**HIGHWAY NO 10 – COOPERNOOK TO HERONS CREEK PACIFIC HIGHWAY
UPGRADE, OPERATIONAL NOISE MONITORING, COOPERNOOK TO
MOORLAND MCoA 53, MOORLAND TO HERONS CREEK MCoA 31.**

**HIGHWAY NO 10 – COOPERNOOK TO HERONS CREEK PACIFIC HIGHWAY
UPGRADE. OPERATIONAL NOISE MONITORING. COOPERNOOK TO
MOORLAND MCoA 53. MOORLAND TO HERONS CREEK MCoA 31.**

Please find the attached responses to your e-mail to Mr Scott Lawrence dated 10 August 2010, in regard to RTA's modification request to bring forward operational noise monitoring to be within 6 months of opening the full length of the Coopernook to Herrons Creek project.

Exert taken from: Samuels. S (Feb 2010) *The Acoustic Attributes of Diamond Ground PCC Pavement Surfaces on the c2HC Section of the Pacific Highway 7 Months After Grinding*. Unpublished. Prepared by TEF Consulting for Roads and Traffic Authority of NSW

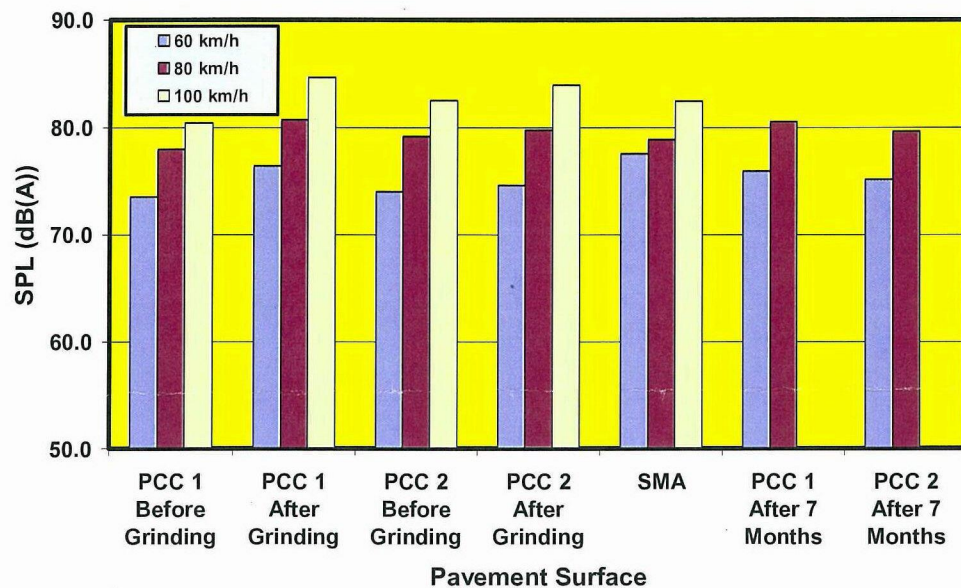
<p>2) Technical requirements such as the integrity/structure of the road pavement and whether the road pavement condition may change as the volume of traffic stabilises to normal traffic flow conditions.</p>	<p>The difference between road generated noises as a result of pavement condition 6 months after opening compared to 2 months after opening would be insignificant. This has been previously demonstrated on studies undertaken by or on behalf of the RTA (ie research undertaken by Dr Stephen Samuels).</p> <p>Dr Stephen Samuels was commissioned by the RTA to investigate noise performance of diamond ground pavements in which part of the works involved measuring noise levels from un-trafficked concrete pavements (PCC) and comparing noise performance of the same pavement 7 months after pavement had been exposed to normal traffic flow/volumes.</p> <p>The attached figure taken from Dr Samuels report shows the insignificant difference between transverse tyned concrete pavements (PCC) 7 months after the initial test were undertaken on new (un-trafficked) pavements.</p>
